TOWN OF WELLS, MAINE
STAFF REVIEW COMMITTEE

Meeting Agenda

Tuesday, March 17, 2026, 9:00 AM

Sheet No.:
C2.0

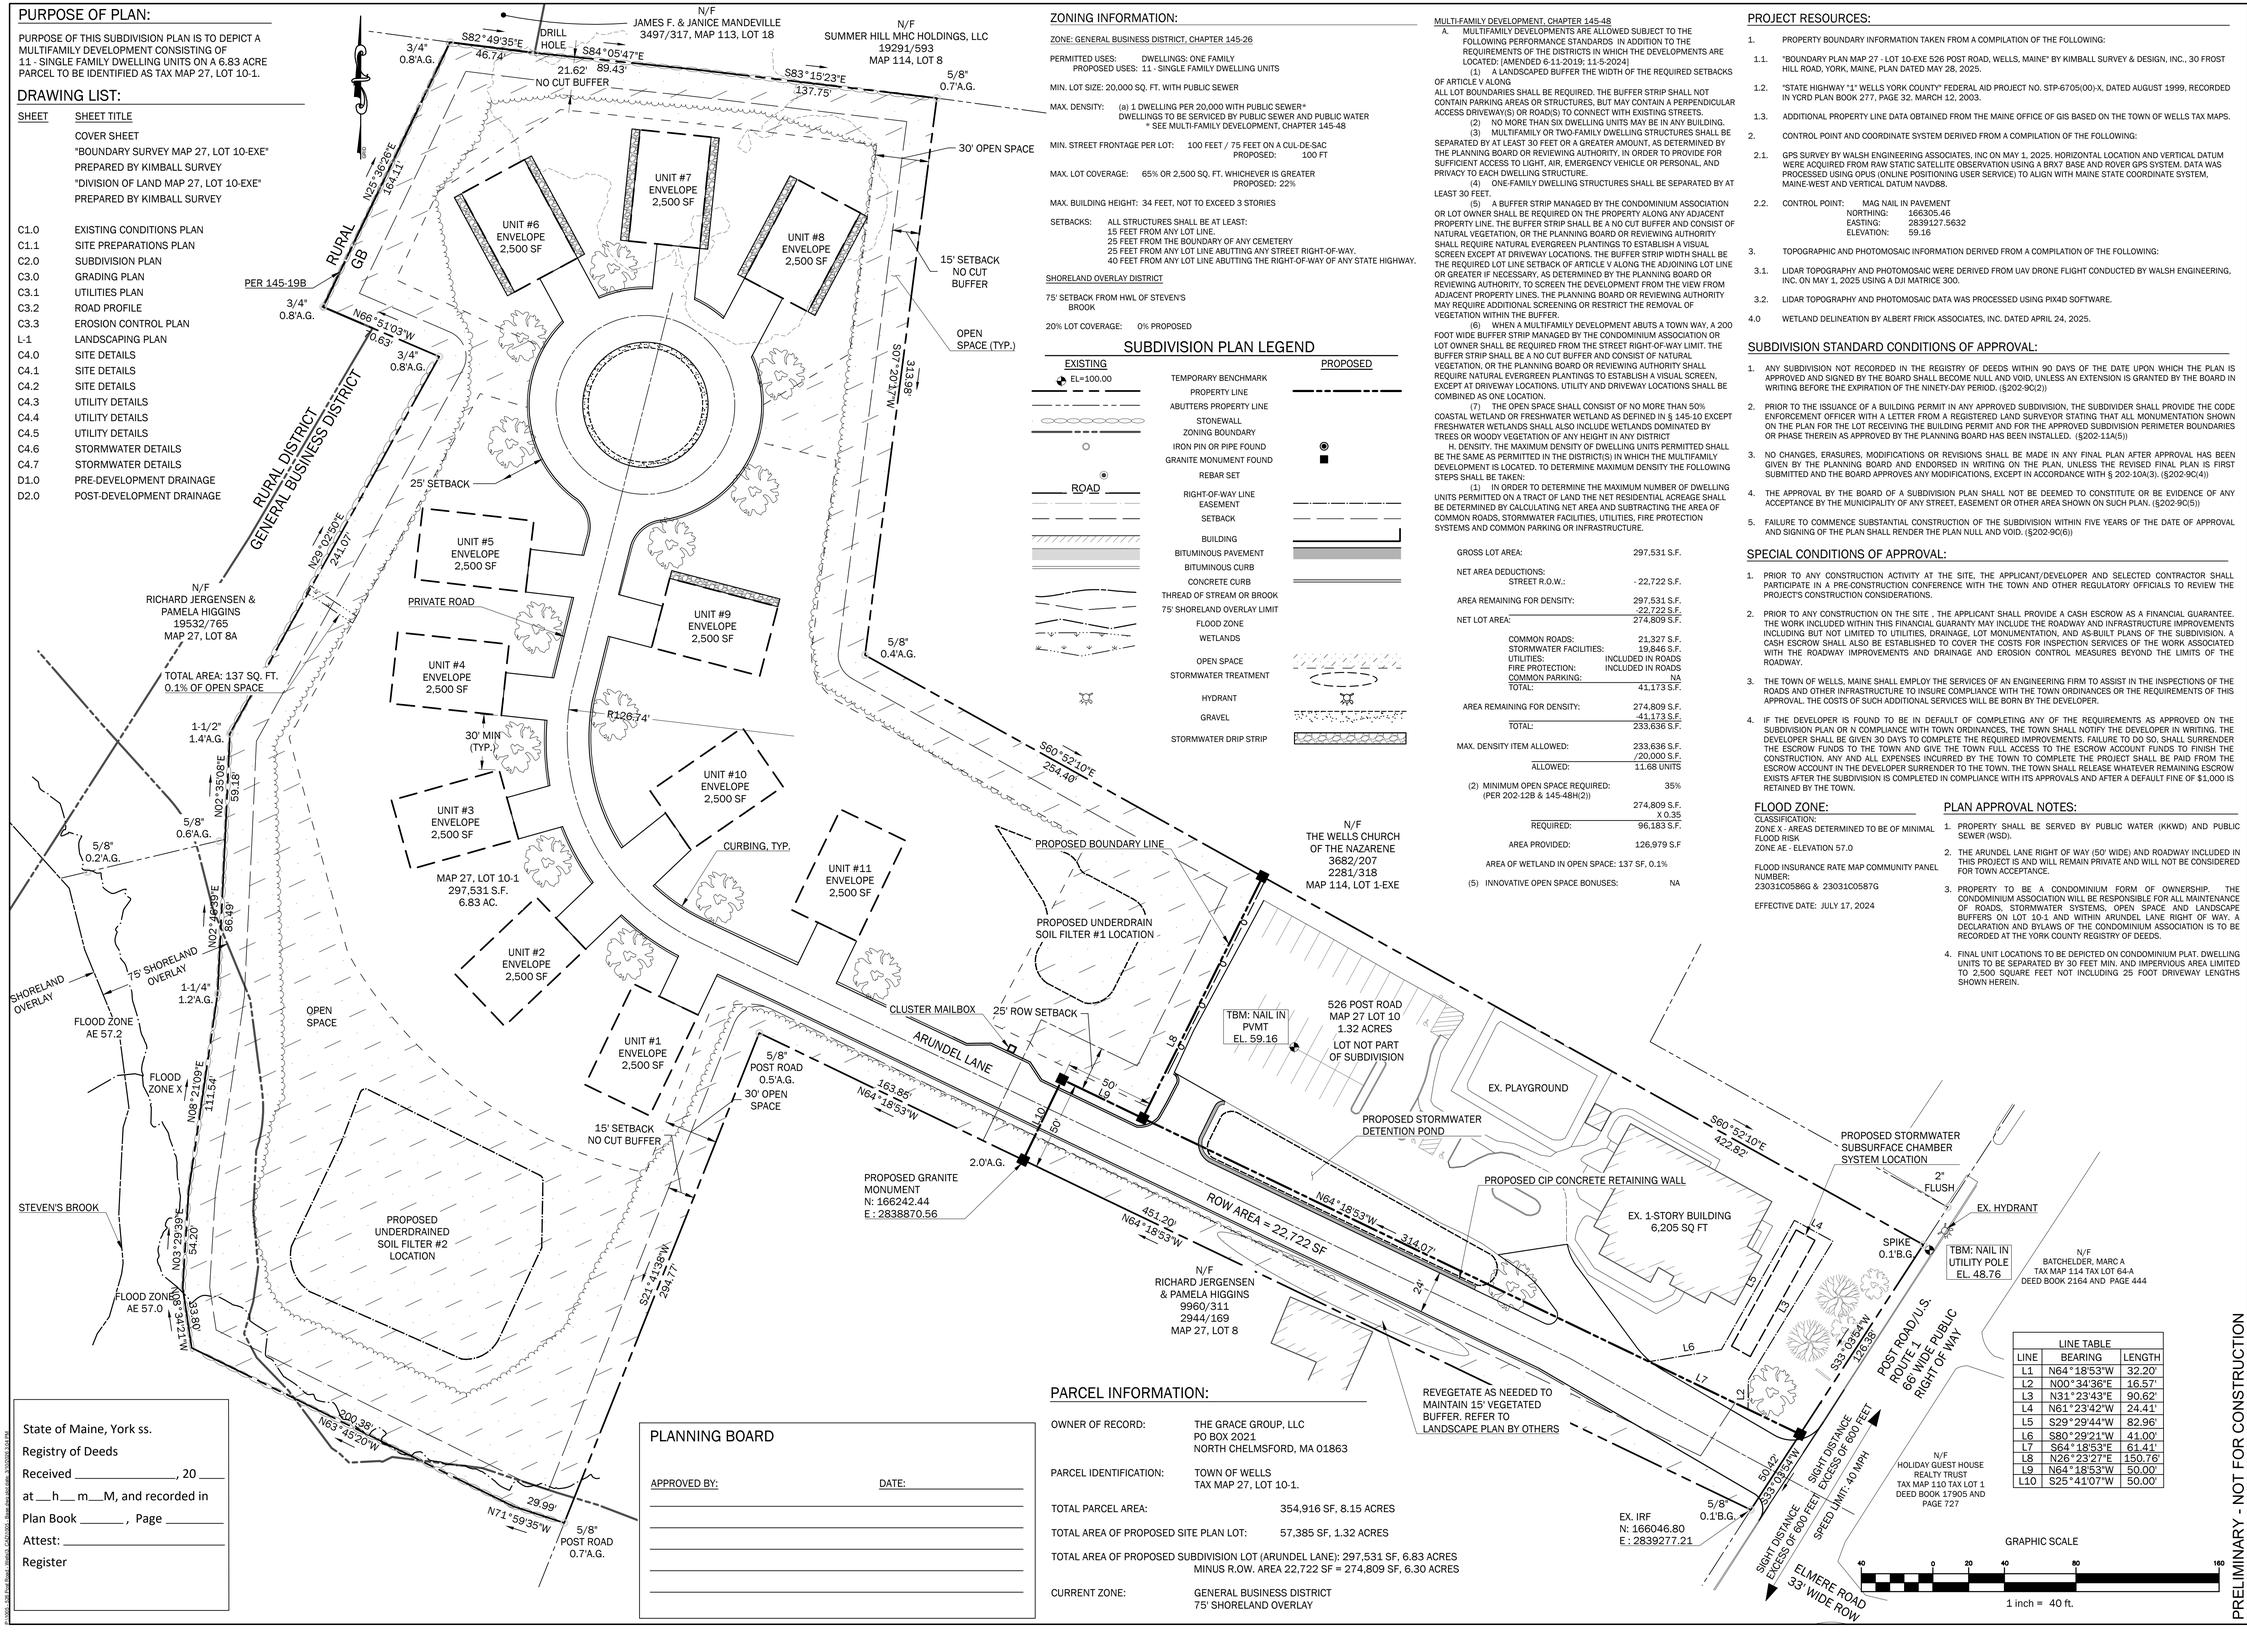
F.(6).a. [3]	Twenty-five feet from any lot line abutting any street right-of-way.	**Parcel does abut the Arundel Lane ROW. 25' setback to be identified.**	Y	C2.0	Proposed 25' setback off of Arundel Lane ROW has been added.
145-48	**PERFORMANCE STANDARDS - MULTIFAMILY DEVELOPMENTS**				
A.(1)	A landscaped buffer the width of the required setbacks of Article V along all lot boundaries shall be required. The buffer strip shall not contain parking areas or structures, but may contain a perpendicular access driveway(s) or road(s) to connect with existing streets	15' wide landscaped buffer along all lot lines noted. **Label corrections needed.** Arundel Lane roadway serving the multifamily development crosses the buffer required from the street ROW.	Y	All Sheets	Labels for the proposed 15' landscaped buffers for the multifamily development have been updated accordingly on all sheets.
A.(4)	One-family dwelling structures shall be separated by at least 30 feet.	**Single family dwellings shall be separated by a minimum of 30 feet. Measurements between the units on the plan appear to be 28 or 29', not 30'.** **Plan provided is not to scale.**	Y	All Sheets	Confirmation that all building envelopes are separated by 30 feet. Plans have been printed with correct margins to provide accurate scale.

ITEM NUMBER	DESCRIPTION	STAFF COMMENT 2/20/2026	COMMENT ADDRESSED	DRAWING / SHEET NUMBER	COMMENT RESPONSE 3/10/2026
F.(3)	Minimum street frontage per lot: 100 feet, which may be reduced to 75 feet for frontage entirely on a cul-de-sac	**The subdivision lot depicts 100' of street frontage on Arundel Lane ROW.**	Y	C2.0	No response necessary
F.(4)	Maximum lot coverage: 65% (20% within the Shoreland Overlay District) or 2500 square feet, whichever is greater, except that the maximum lot coverage shall be 40% of the entire lot on any lot that was legally created prior to January 1, 1994, if at least 75% of the lot is located within the Shoreland Overlay District	The 65% maximum lot coverage of the GB zone is noted on the plan. The proposed lot coverage is 22%. The 2,500 SF boxes on the plan are building envelopes.	Y	C2.0	No response necessary
F.(6).a. [3]	Twenty-five feet from any lot line abutting any street right-of-way.	**Parcel does abut the Arundel Lane ROW. 25' setback to be identified.**	Y	C2.0	Proposed 25' setback off of Arundel Lane ROW has been corrected.
